Fire technical assessment

Name of sponsor: Bygcom A/S
Product name: Symmetrical 2-layer gypsum wall – EI60
File no.: PHA11192F
Date: 28-05-2019
Pages: 4 **Encl.:** 1
Ref: MKL / NOL

Non-Loadbearing wall

EI60 Max. 3m høj

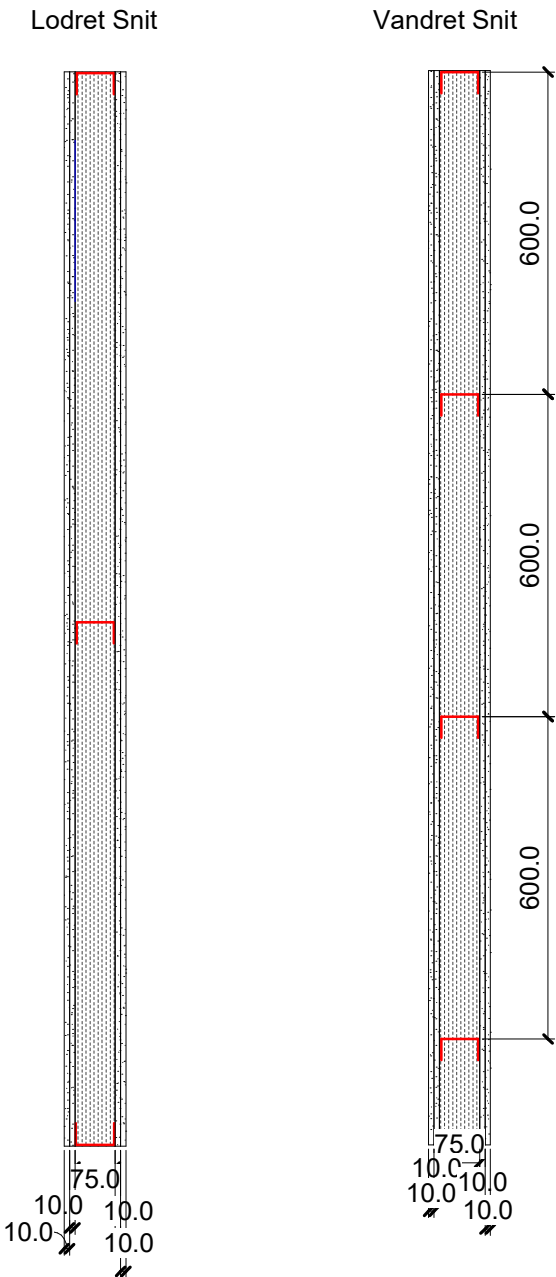
The construction shown on the attached drawing consist of two layer of Fermacell fibre board (10 + 10 mm) on each side of cc 600 mm steel studs with a width of 75 mm and a steel thickness of 1.2 mm designated Bygcom 75x1.2. Stone wool insulation with a nominal density of at least 30 kg/m³ is mounted between the steel studs.

The only changes to the assessed wall is the type and thickness of the studs and the total thickness of the Fermacell fibre boards. The change in stud type and the increase in stud and Fermacell fibre boards thickness will not deteriorate the performance of the wall and can in some cases improve the stability of a wall during a fire test.

Based on the given documentation, DBI assesses that the wall shown on the attached drawings fulfils the requirements for a non-loadbearing wall with the classification EI60.

- The following changes are allowed (taken from the DIAP in EN 1364-1:2015)
 - Decrease in height (max 3000 mm)
 - Increase in the thickness of the wall (minimum 115 mm thick)
 - Increase in the thickness of component materials
 - Increased in the width of the studs
 - Decrease in linear dimensions of boards but not thickness
 - Decrease in stud spacing
 - Decrease in distance of fixing centres
 - Increase in the number of horizontal joints
 - Unlimited increase in the width of the wall
- All other details must be constructed as described in test report 2006-CVB-R0193
